### APPEAL SUMMARY

**Appeal ID:** 20701

**Project Address:** 4725 NE Mason St

**Appeal Involves:** Alteration of an existing structure, other:  
Create ADU in SFR

NEW ADU FLOOR PLAN  
 SCALE: 1/2" = 1'-0"

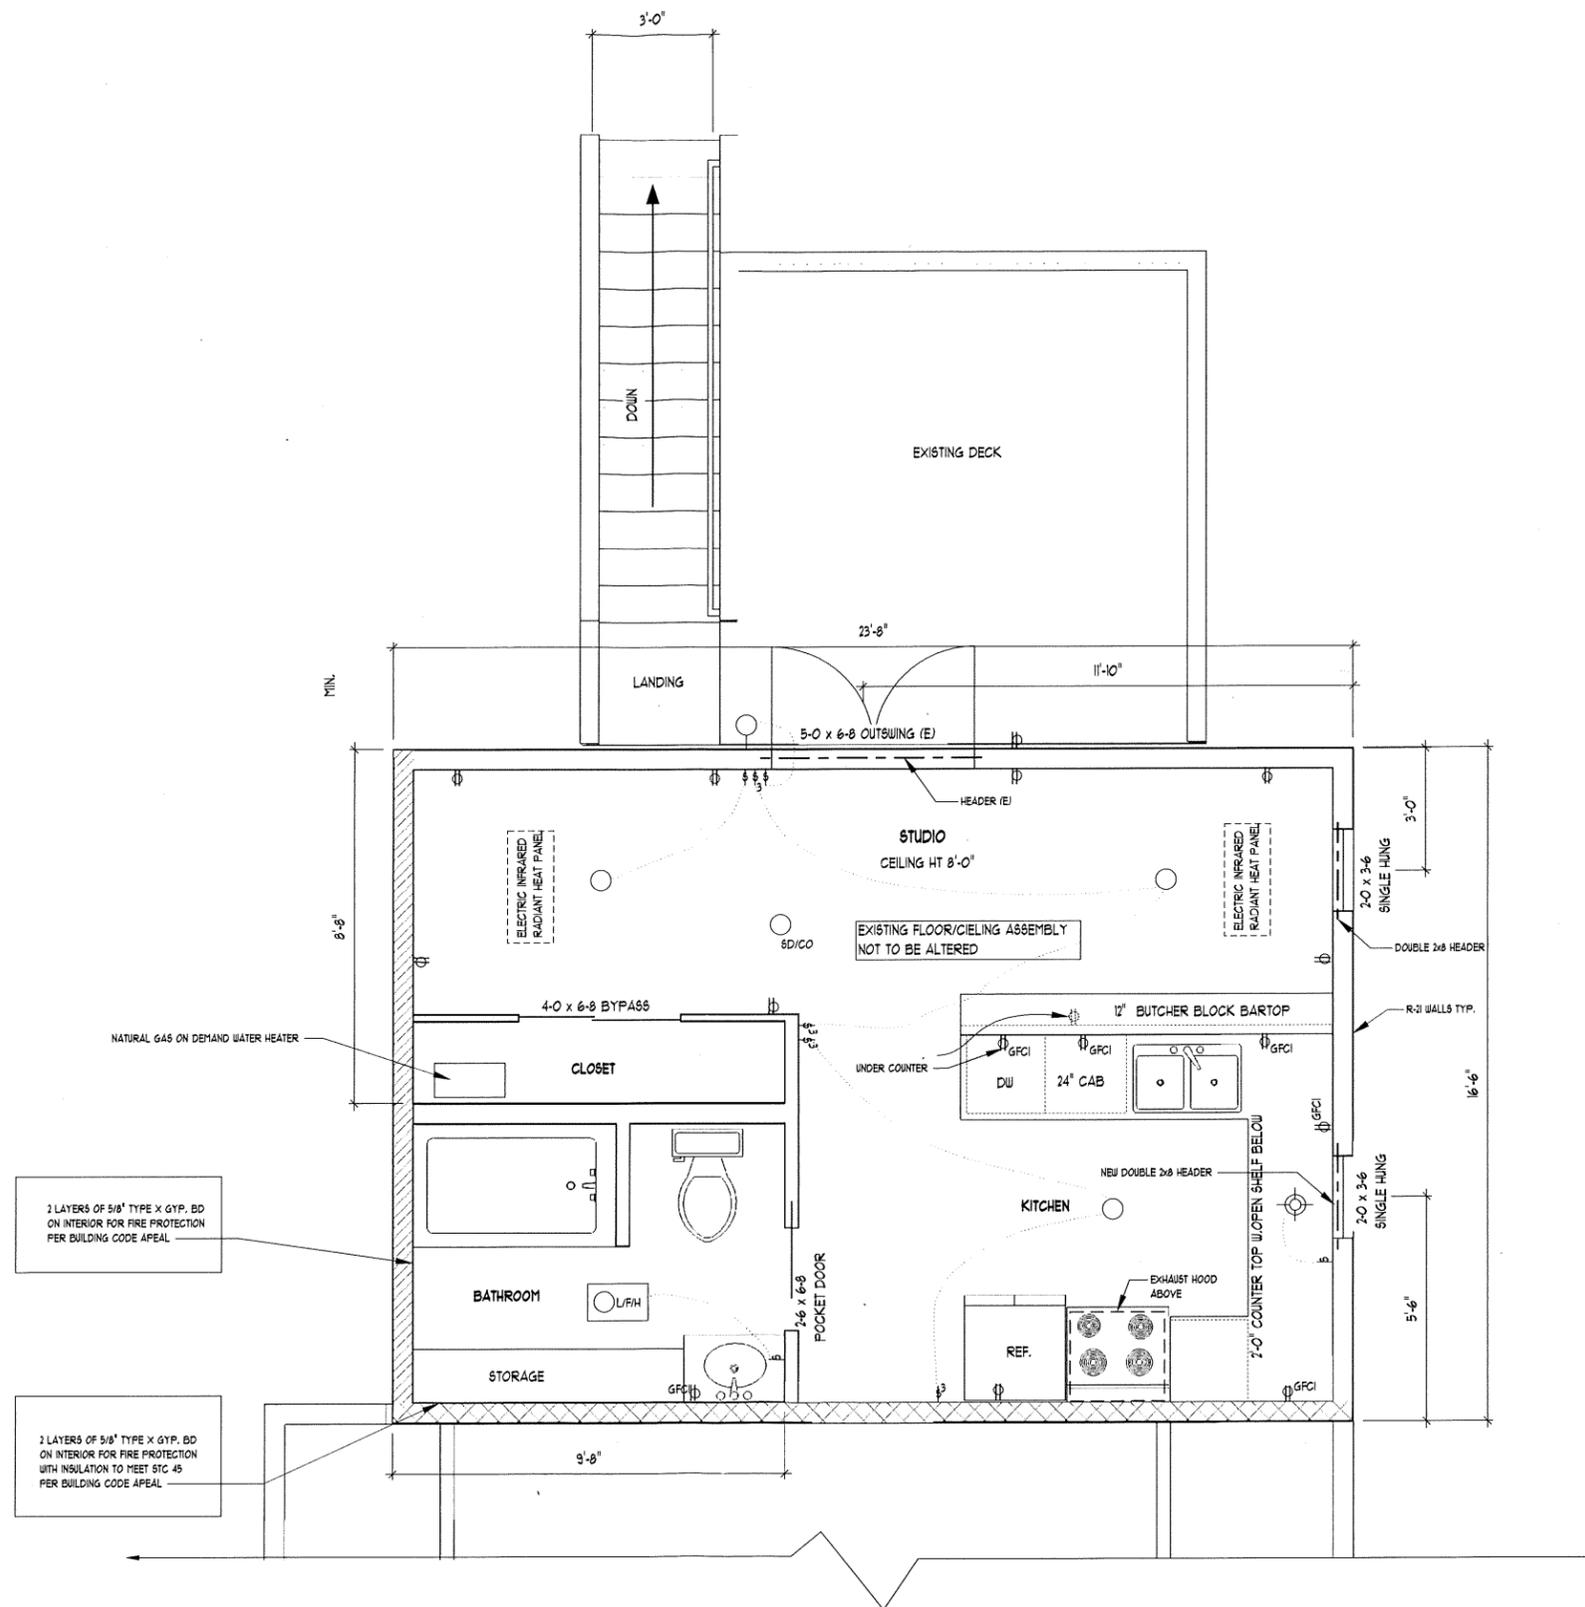
**Code Section** R302.1 (table) and ADU Code Guide

**Requires** 5/8" X type gyp. board per side (1-hour wall, STC 45). Creating ADU. This space was finished 7/19/19 as SFR addition.

**Proposed Design** 2 layers Type X 5/8" gyp. bd. on the interior only on South and West walls.

Reconsideration text: Horizontal separation between the ADU and the main residence is provided by existing ceiling finishes per Portland Program Guide for Accessory Dwelling Units. There are no additional living units on the property.

**Reason for alternative** To avoid rebuilding exterior of existing addition. (Would be cost-prohibitive).

#### Alternate 1 hour wall assembly with 2 layers of 5/8" Type X gypsum: Granted as proposed.
